Docket Item # 5
BAR CASE # 2008-0016

BAR Meeting
May 28, 2008

ISSUE: Addition and Alterations
APPLICANT: Arthur Garden and Maribeth Monti
LOCATION: 320 North Patrick Street
ZONE: RB/Residential

Figure 4. Proposed elevations.

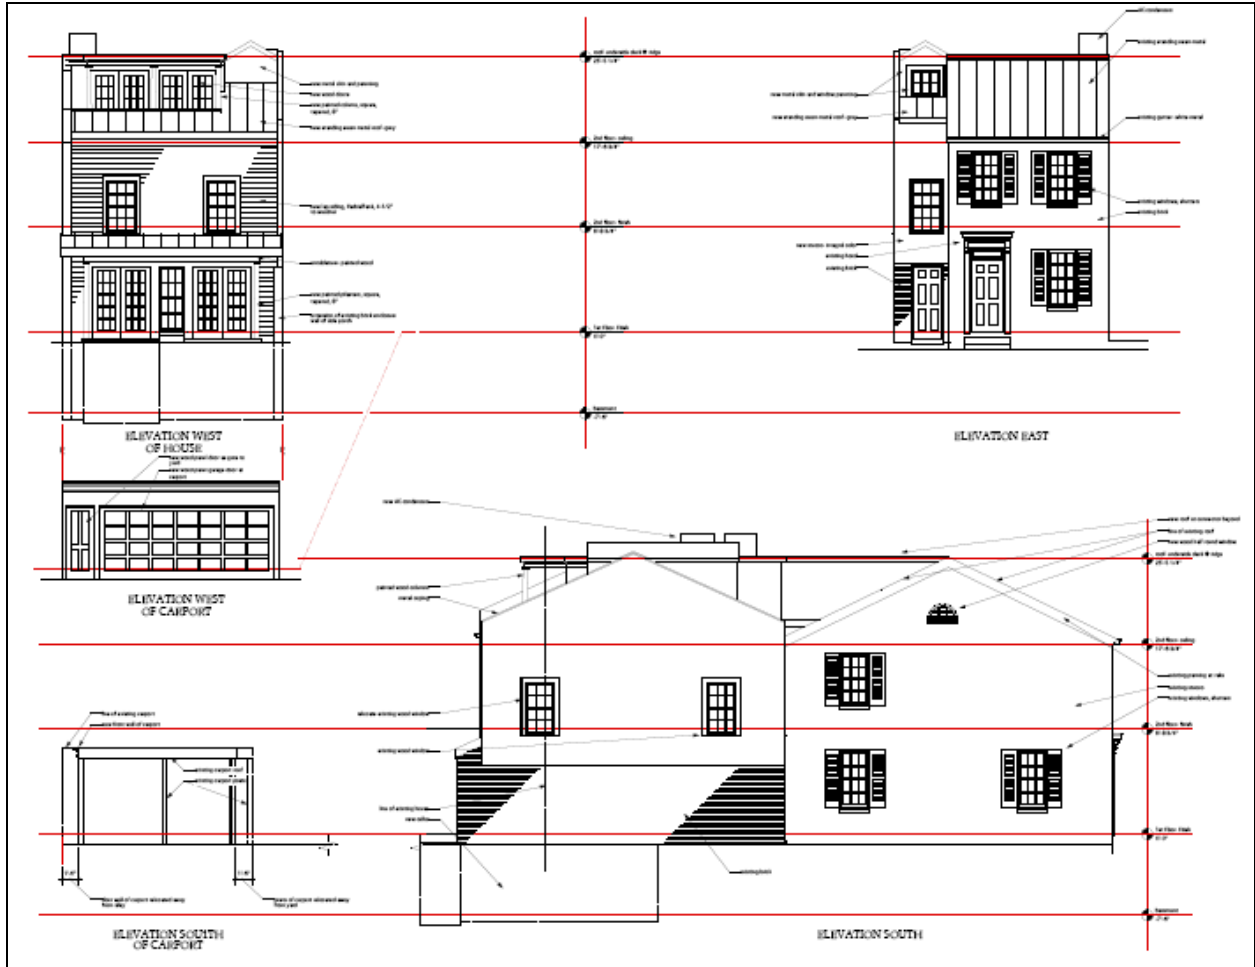
In respect to architectural character, Staff believes that the approach for the addition, which includes selecting design cues from the original, such as roof form and materials, allows for the addition to read as new, but still compatible and respectful of the original building and the surrounding district. As proposed, the addition will provide a more harmonious rear elevation to the building than the existing conditions. Staff is also supportive of the removal and reconfiguration of the HVAC units. The Zoning Ordinance does require that HVAC units located on rooftops be screened unless the Board approves Waiver of Required Screening of HVAC units. The applicant has not requested a Waiver of Required Screening, nor shown proposed screening. It is unclear what the applicant desires to do with the HVAC unit so conditions are noted by Staff.

Therefore, Staff supports the application and the alterations such as the new half round wood window on the original south elevation. However, Staff would like to review and approve window and door specifications for the addition and the carport.

- 1) That the applicant provide to Staff manufacturer information and specifications on the proposed new windows and doors for the addition and carport;

- 2) That the applicant indicates on the permit drawings the screening mechanism for the new HVAC units as required by code for Staff review, or if screening is not desired, apply for a Waiver of Required HVAC screening; and,

Figure 7. Bird's eye view of proposed addition.

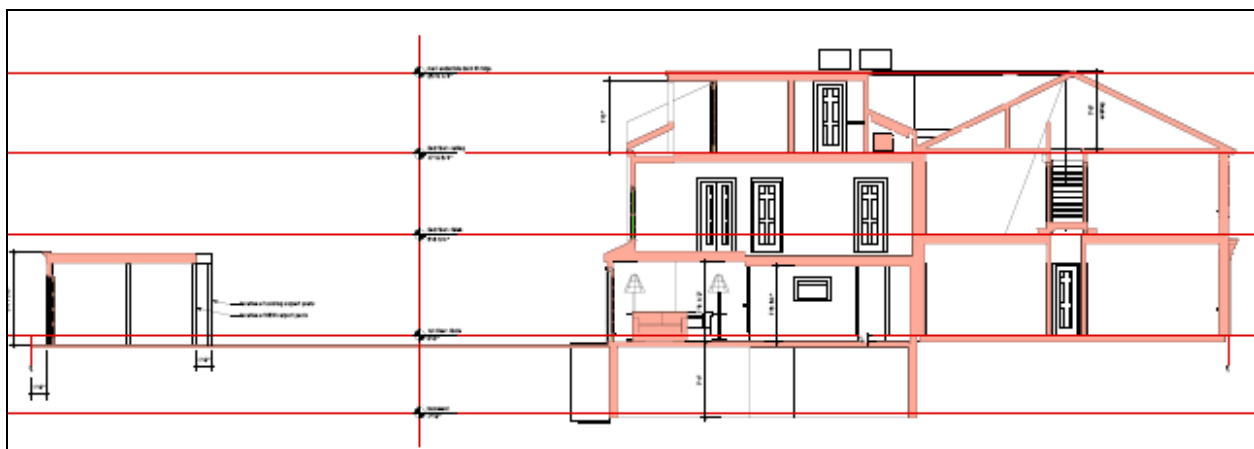
Connector: In order to connect the attic space in the original house to the third floor area of the addition, a connector element with a flat roof will be added. The connector is located on the north side of the property (see bird's eye view image.)
